ROBINSON ACRES SUBDIVISION

APPLICATION NUMBER 17 DATE November 3, 2005
APPLICANT Robinson Acres Subdivision
REQUEST Subdivision

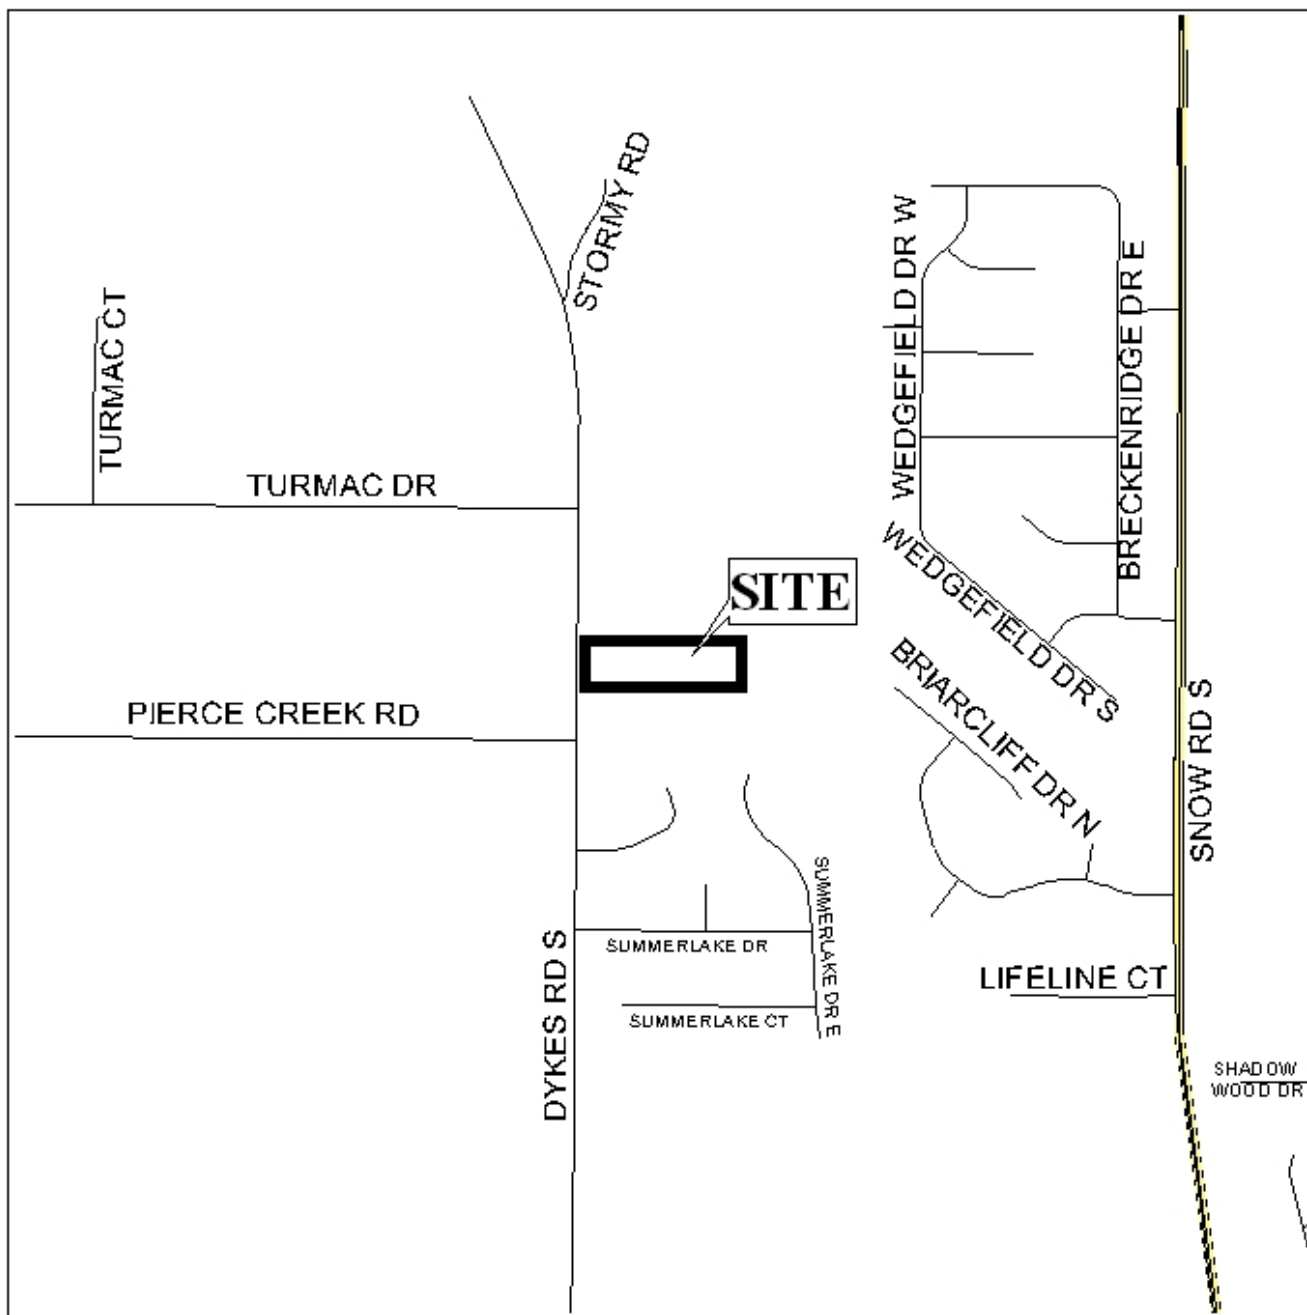
The purpose of the application is to create a two-lot subdivision from two metes and bounds parcels. It should be noted that there is a typographical error in the legal description on the preliminary plat, which should be corrected on the final plat.

At the rear of proposed Lot 2 is a lake; therefore, necessary approval from all applicable federal, state, and local agencies must be obtained prior to the issuance of any permits.

Proposed Lot 2 is also unusual in that it is flag-shaped. While this is not typical for the area, it is essentially a mirror image of the configuration of the two parcels immediately to the South, which are not lots of record. As the site is quite large and, due to being waterbound on one side, cannot otherwise subdivide with access to a public road, this configuration appears appropriate in this case.

There is a landlocked parcel the rear of the site that ordinarily would require a street stub; however, the lake makes this an impossibility.

With a waiver of Section V.D.1 (shape of lots), the plat will meet the minimum requirements of the Subdivision Regulations, and is recommended for Tentative Approval, subject to the following conditions: 1) that there will be no further resubdivision of Lot 2 until and unless additional frontage on a publicly maintained street is available; 2) that all necessary approval from all applicable federal, state, and local agencies be obtained prior to the issuance of any permits; 3) the placement of a note on the final plat stating that any lots that are developed commercially and adjoin residentially developed property must provide a buffer, in compliance with Section V.A.7 of the Subdivision Regulations; and 4) the correction of the legal description on the final plat.
